Timestamping with Transmitter Skew: Follow-Up and Proposed Amendments

Andras de Koos

October, 2020

Tx Skew Midpoint – Unmeasured path delay

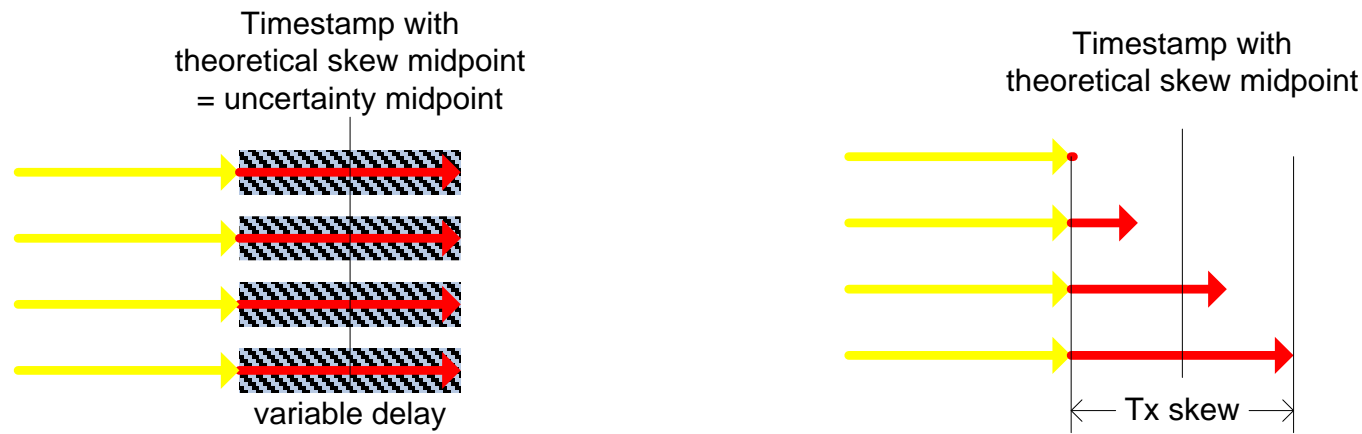
Using the Skew midpoint as the timestamp point is conceptually similar to timestamping with respect to the middle of the uncertainty window for a single-lane Ethernet PMD:

Assuming there is an unmeasured delay associated with a lane, the timestamp would generally be in the middle of the known uncertainty window, in order to minimize the total timestamp error.

For a multilane interface, the skew can be seen as the midpoint between the minimum and maximum transmit delays for each lane. *If there are no other skew contributors*, then the maximum skew between the lanes is exactly equivalent to the range of the single-lane uncertainty.

As such, if there is an *unmeasured* transmit path delay uncertainty for each lane, then the time synchronization error on a multi-lane PMD from timestamping at the skew midpoint is no worse than the time synchronization error on a single-lane PMD.

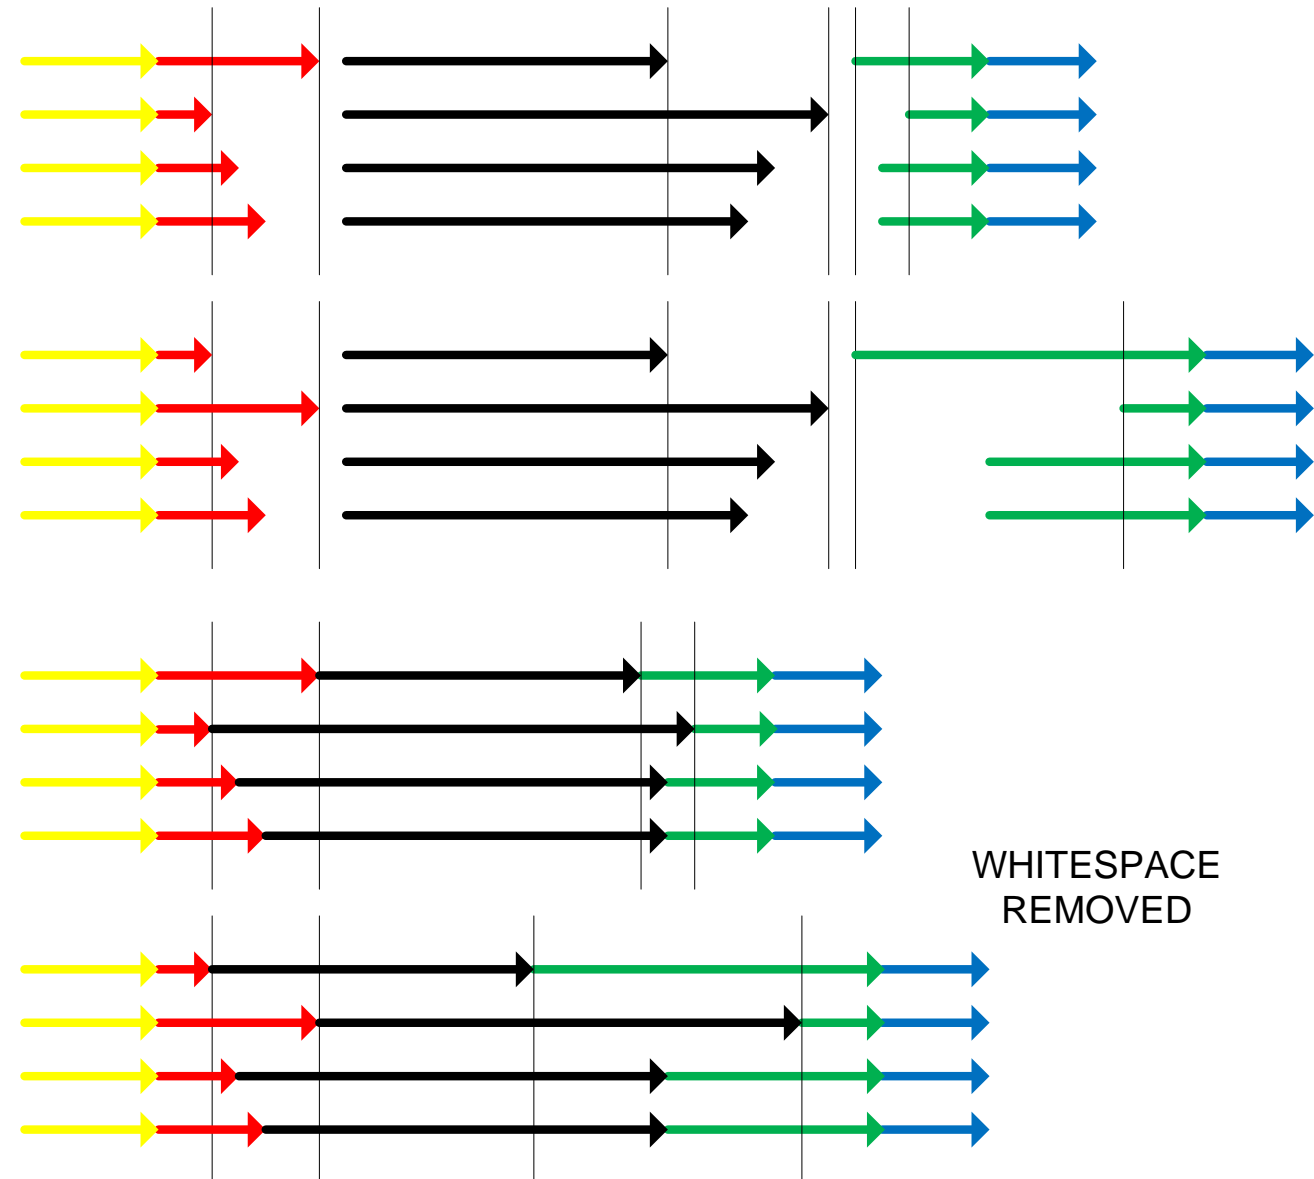
2. The proposed Tx Skew paragraph for 90.7 contains background information. Typically, 802.3 specifies what to do, but rarely the rationale behind the directives.

“Since transmit skew in series with medium skew is not strictly additive, transmit skew can contribute to time synchronization error by obscuring the actual latency of the medium.”

Though the background information is valuable, its inclusion may seem out-of-place in 802.3, and reflects this author’s preference for verbosity.
